**TECHNICAL BULLETIN**  
**Bell Helicopter** **TEXTRON**  
A Subsidiary of Textron Inc.

**NO** 407-99-18

**MODELS AFFECTED:** 407

**SUBJECT:** **DISC PACK COUPLING 407-340-340-101, INTRODUCTION OF.**

**Figure 1. Flywheel and Fan Shaft Wear Limits**

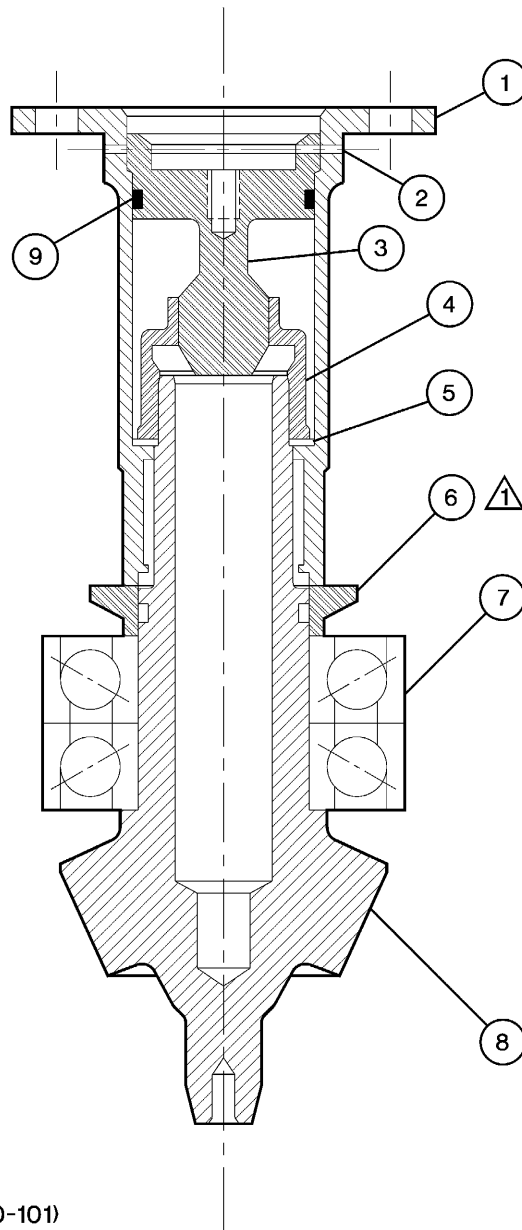
2. Remove the forward shaft assembly, the aft shaft assembly, and the four bearing and hanger segmented shaft assemblies. (Refer to Maintenance Manual BHT-407-MM-7, Chapter 65, for the removal instructions.)
3. Make sure that the splines of the flywheel, the splines of the fan shaft assembly, and the splines of the adapter are within the specified wear limits. (Refer to the Maintenance Manual BHT-407-MM-7, Chapter 65, for the inspection instructions and to Figure 1 for added wear limits).

**Figure 2. New Adapter – Installation**

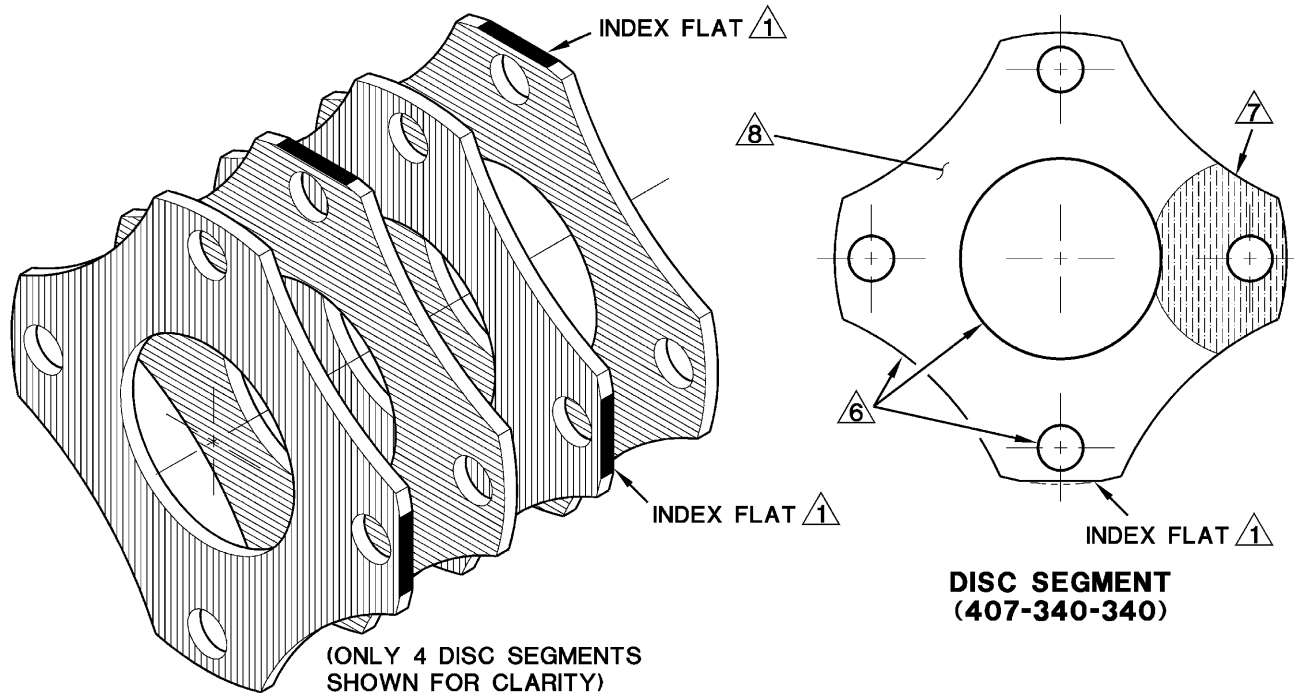
## **PART II: Installation of the New Tail-Rotor Gearbox Adapter 407-040-440-101**

1. Remove the tail-rotor gearbox-adapter 406-040-440-101. Discard the adapter 406-040-440-101, the retainer MS16625-3150, the plug 406-040-442-101, the lockspring 406-040-441-101, the retainer M27426-3139B, and the packing M83248/1-125. (Refer to BHT-407-CR&O manual, Figures 65-5 and 65-6 for accomplishment instruction.)
2. Install the adapter (1, Figure 2), the washer (5), and nut (4). Apply torque 80 to 100 FT-LBS to nut (4). Install the plug (3), the packing (9), and the lockspring (2) as shown in Figure 2. (Refer to BHT-407-CR&O manual, Figure 65-6, for the required torque.)
3. After you do the modification, use a vibrating stylus and mark the tail-rotor-gearbox assembly data plate as follows:

Do not move the seal (6) when you remove the adapter (1).
